Re: Armored Cap Enhancement Work Plan
San Jacinto River Waste Pits Superfund Site Time Critical Removal Action United
States Environmental Protection Agency, Region 6, CERCLA Docket No. 06-12-10

USACE CONCLUSIONS AND ANCHOR QEA RESPONSES

Re: San Jacinto River Waste Pits Superfund Site Time Critical Removal Action
Response to USEPA Questions on TCRA Cap Assessment
CERCLA Docket No. 06-12-10

Attachments: Figure 1 – Armored Cap Enhancement Plan
Letter dated June 14, 2013

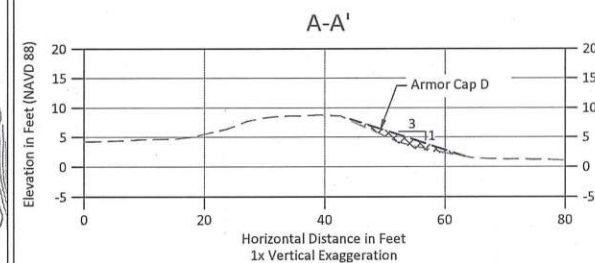
Using the October 2013 quarterly inspection survey data, Anchor QEA has delineated areas that have slopes steeper than 1V:3H within the wave runup or surf zone of the TCRA armored cap. As shown in Figure 1, seven discrete areas have been identified. The Respondents will reduce the slopes of the seven areas to 1V:3H with stockpiled Armor Cap D rock. The use of D rock to reduce the slopes was modeled for and discussed in the Draft FS (Appendix B). As described in Appendix B of the Draft FS, the D rock ($D_{50}=10$ inches, $D_{85}/D_{15}=1.55$) exceeds the computed Maynard equation D_{50} particle size (Anchor 2013) and has a larger D_{50} than the C rock. The Armor Cap D rock also has a uniformity coefficient that falls within the recommended range provided by the Transportation Research Board (NCHRP 2006). The use of Armor Cap D rock provides an increased level of stability, a factor of safety of 1.5, and addresses the enhancement outlined in the USACE's report. The proposed construction requirements, construction schedule, and QA/QC procedures, and plans for the continued implementation of the OMM Plan, are described below.

To reduce the slopes to 1V:3H or flatter, the contractor will transport the Armor Cap D rock from the stockpile and place the rock in the locations shown in Figure 1. Using a small loader (Bobcat, Skid Steer or equivalent equipment as appropriate), the contractor will transport and place the rock in a manner that prevents breakage of the rock. The contractor's survey crew will monitor the rock placement to confirm the required grades are met during construction. After the contractor has completed the rock installation, the areas will be re-surveyed to confirm the slopes are 1V:3H or flatter. The Armor Cap D stockpile is located approximately 15 miles away from the TCRA Site. The Armor Cap D rock meets or exceeds the TCRA original design requirements for each area of the armored cap. The Armor Cap D rock was purchased and stockpiled expressly for maintenance purposes and has already been tested and approved for gradation and chemistry.

Figure 1
Gradation of Armor Rock B/C
San Jacinto River Waste Pits Time Critical Removal Action

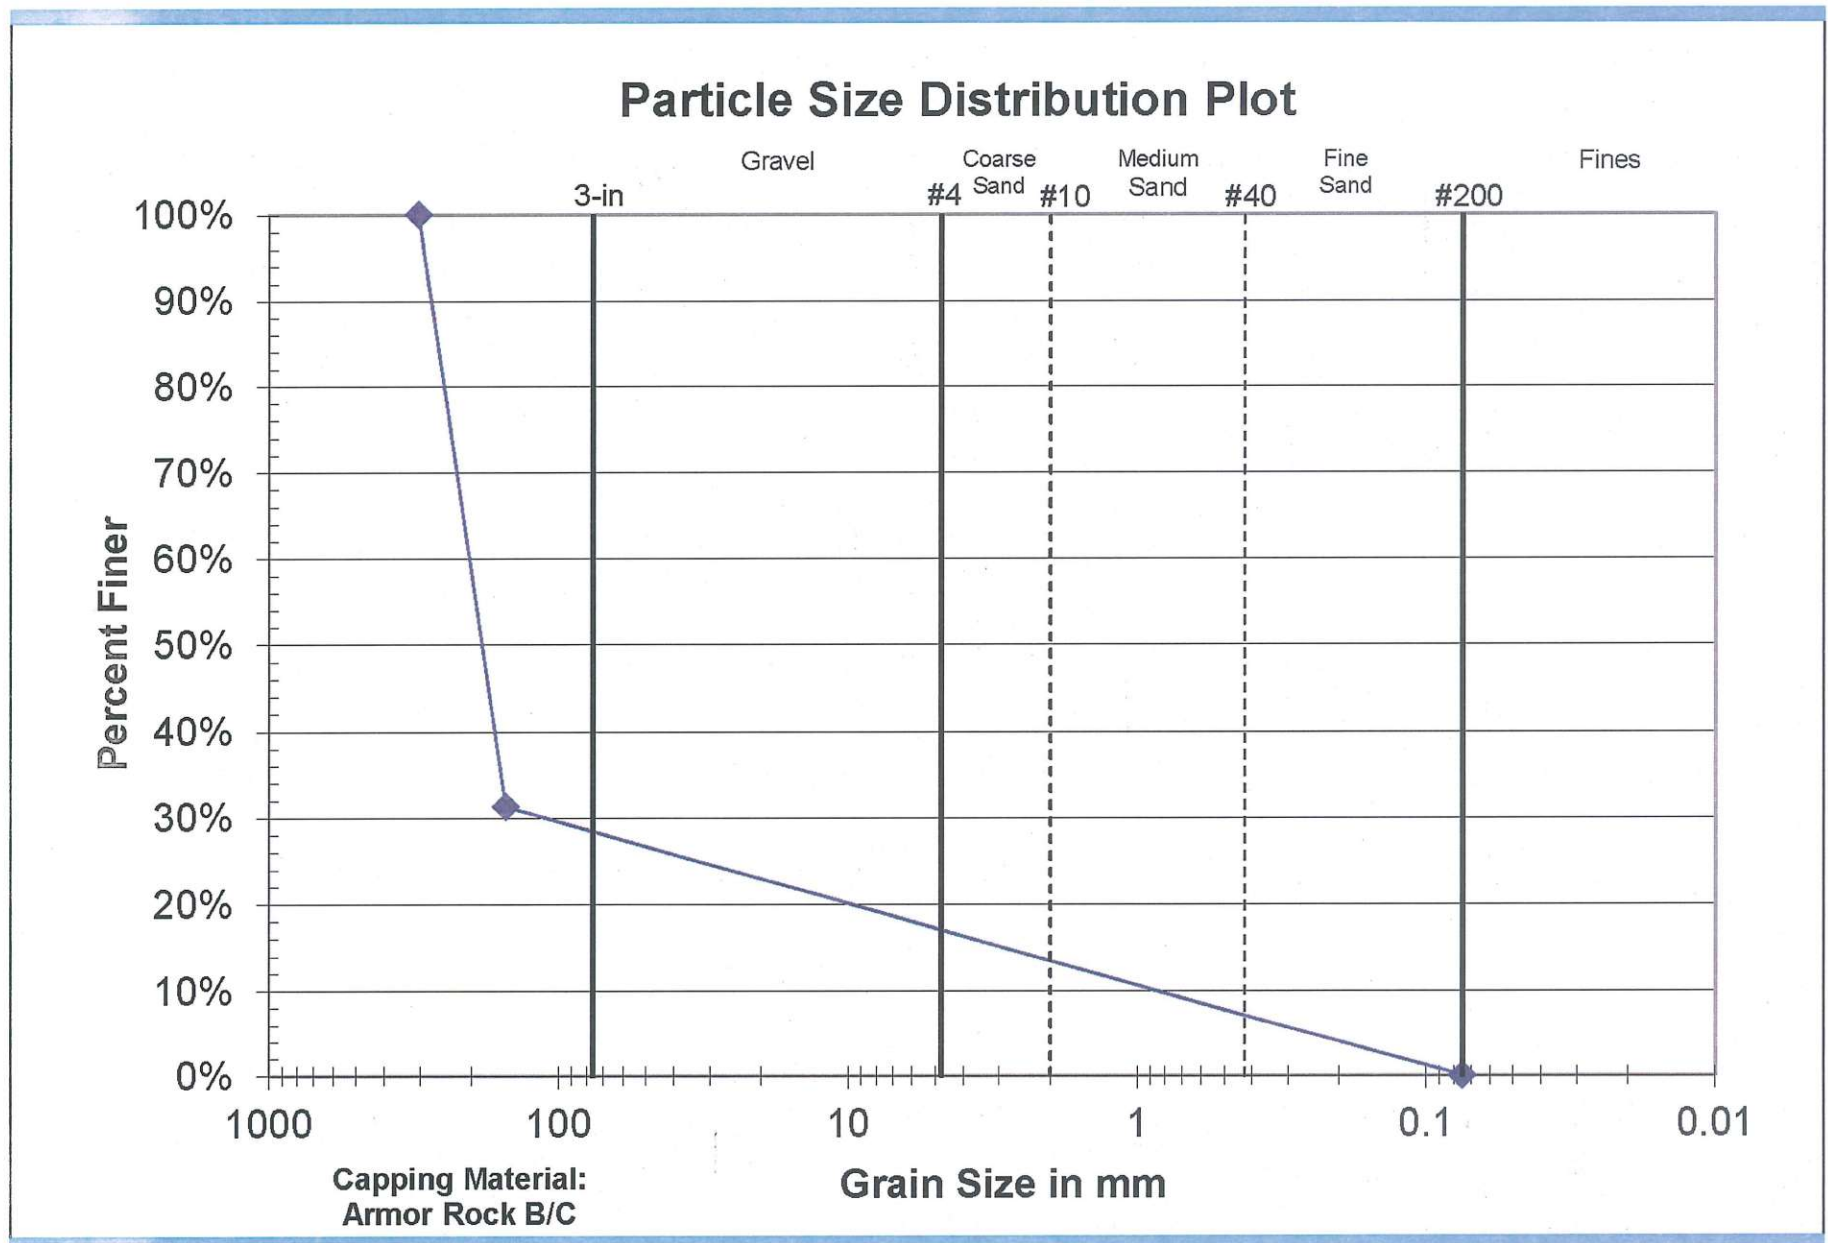
2. What is the measured or estimated grain size distribution for the B/C armor material? Specifically, what are the

- a. D_{100}
- b. D_{85}
- c. D_{60}
- d. D_{50}
- e. D_{15}
- f. D_{10}
- g. D_{30}

Using the contractor gradation submittal for the B/C armor material, the following is the measured and estimated grain size distribution for this material:

- D_{100} 12 inches
- D_{85} 9 inches
- D_{60} 8 inches
- D_{50} 6 inches
- D_{30} 4 inches
- D_{15} 0.12 inches
- D_{10} 0.033 inches

A grain size distribution curve for this material is attached for reference.
